**BL580 Institute Disability & Community
Chiller Capacity and Operational Rehab**

ADDENDUM NO. 1

HEAPY PROJECT NO. 2025-06024

June 5, 2025

M200

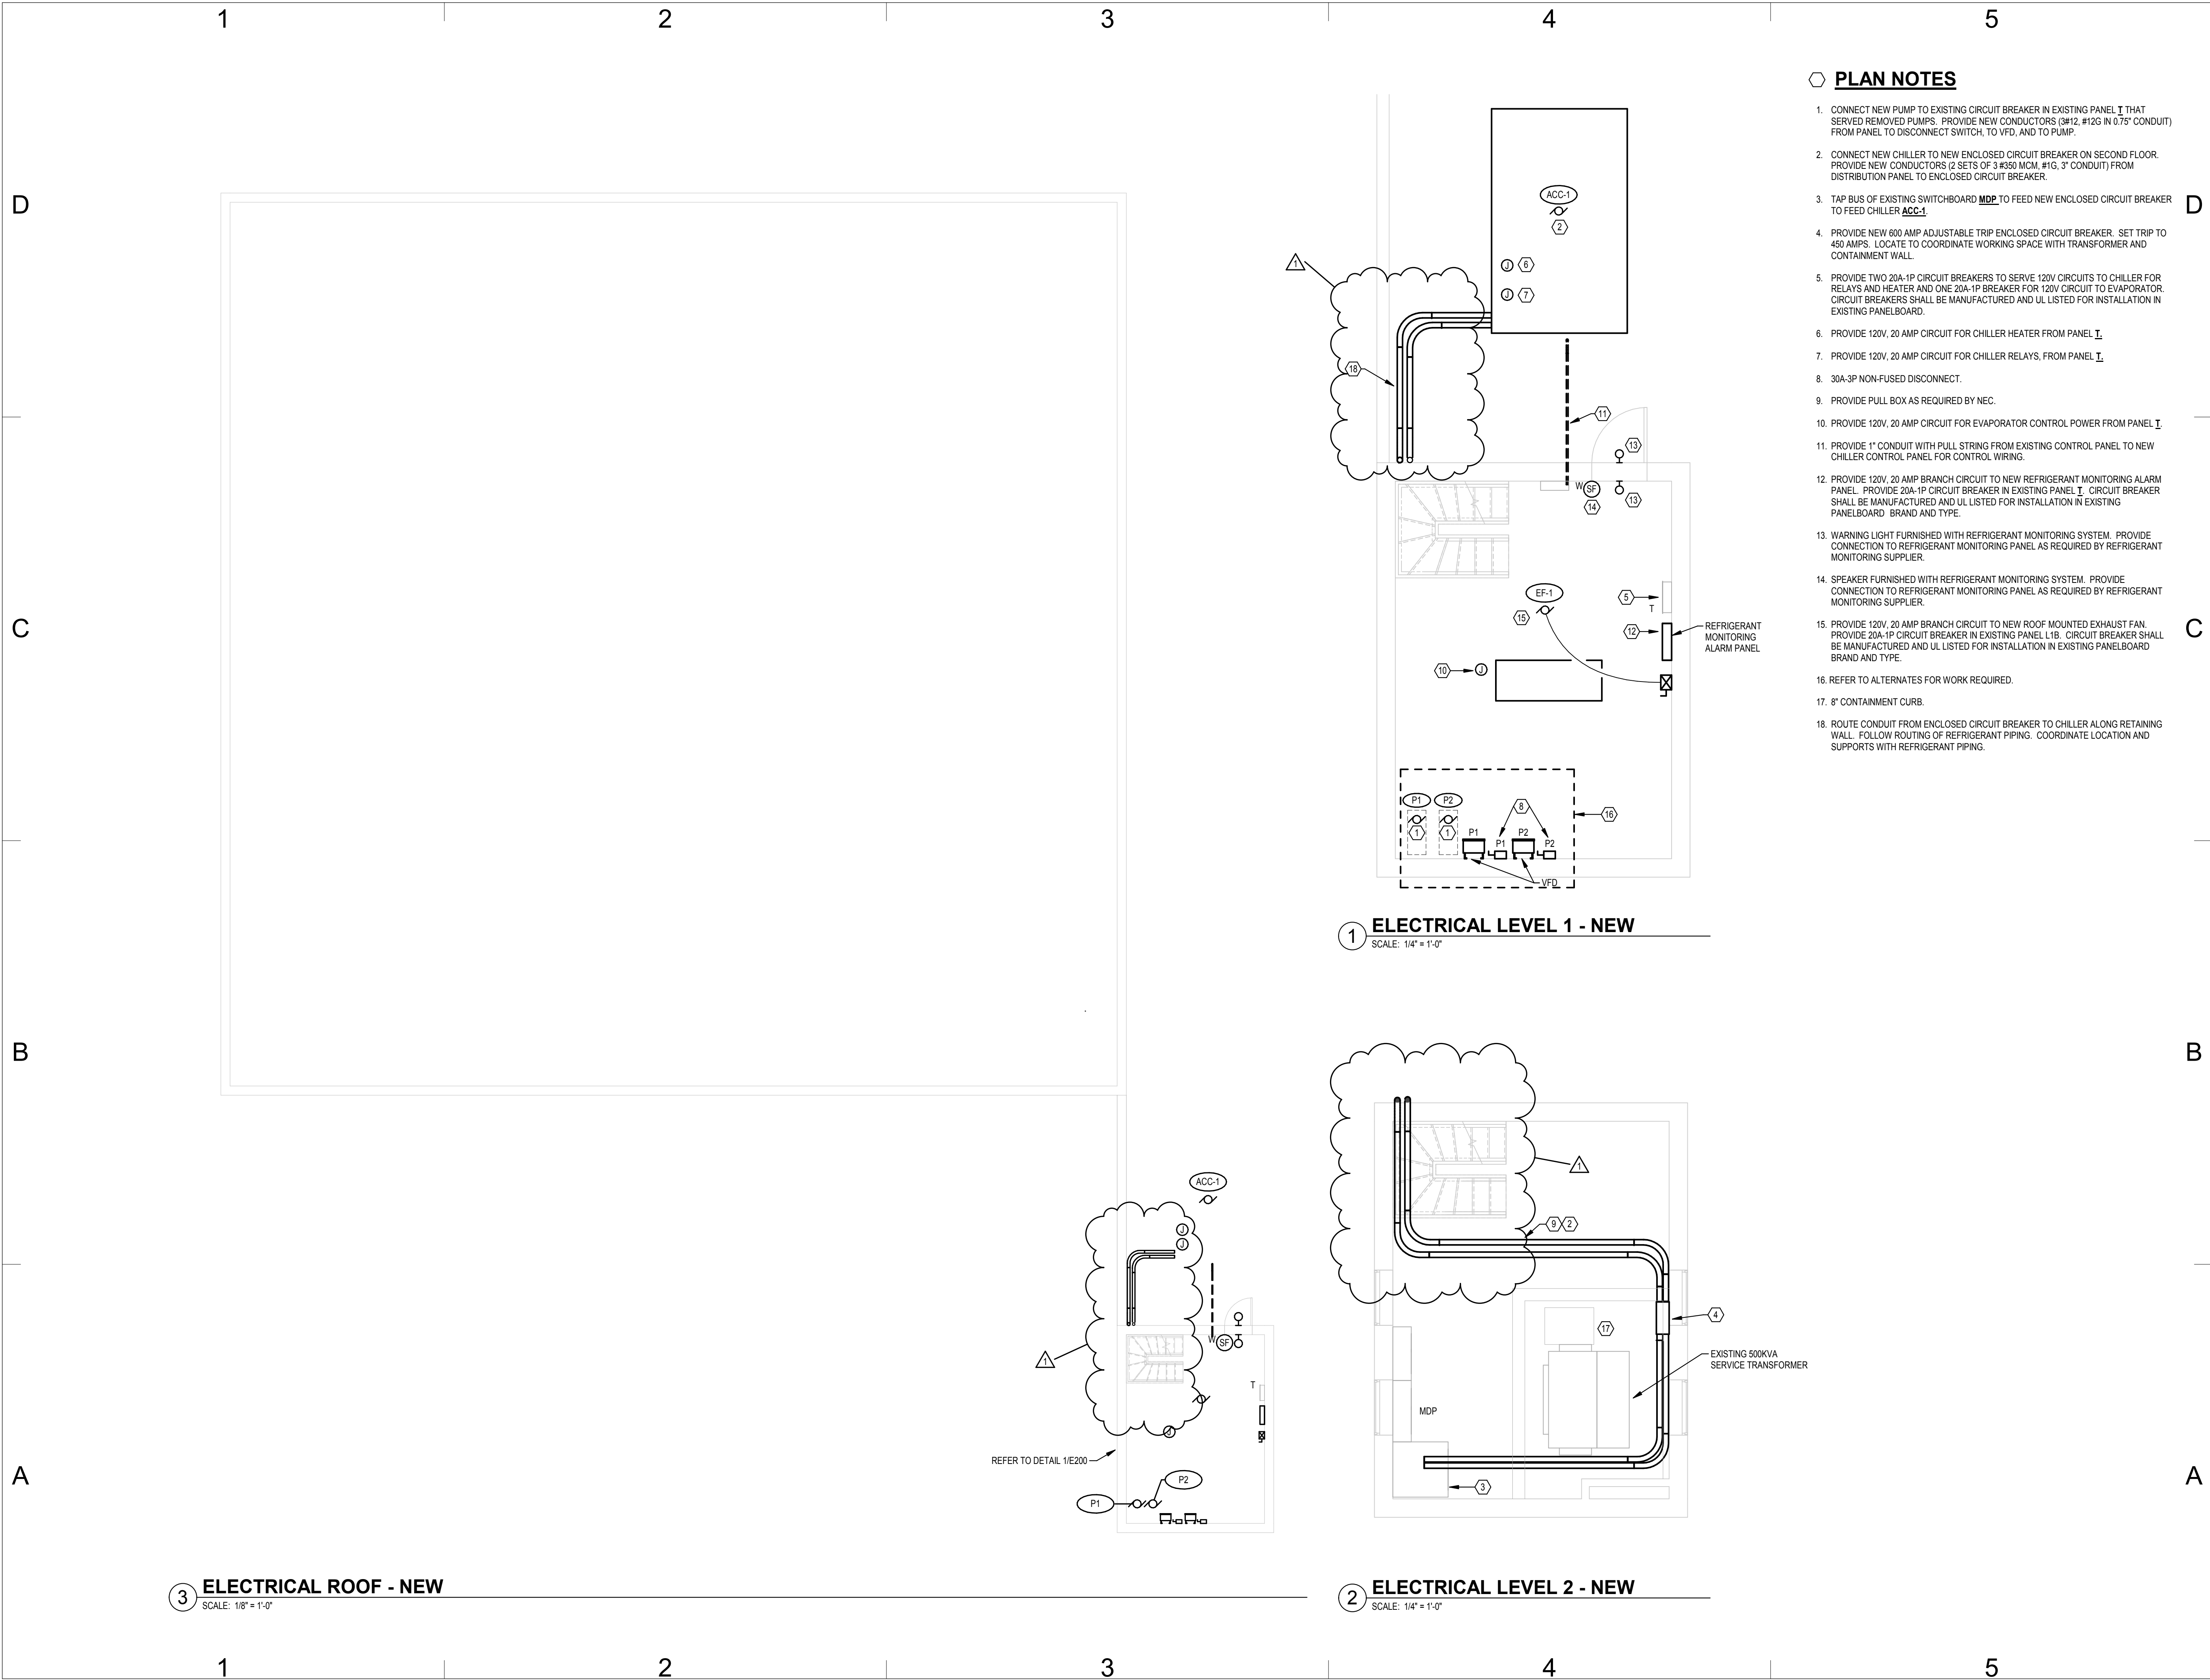
- ITEM NO. 1 E200 ELECTRICAL NEW
- A. REVISE CONDUIT ROUTING TO CHILLER.
- ITEM NO. 2 M200 HVAC NEW
- A. REVISED REFRIGERANT ROUTING.
- B. REVISED NOTE 4.
- C. REVISED UNIT LOCATION.
- D. REVISED FENCING AND GATE LOCATION.

- 4 REFRIGERANT LINES TO BE SLOPED PER MANUFACTURER REQUIREMENTS. PIPING TO GO THRU WALL INSIDE PROTECTIVE SLEEVE. REFRIGERANT LINE SIZES AND SPECIALTIES PER EQUIPMENT MANUFACTURER.

- 12 FENCE GATE TO BE LOCATED HERE.
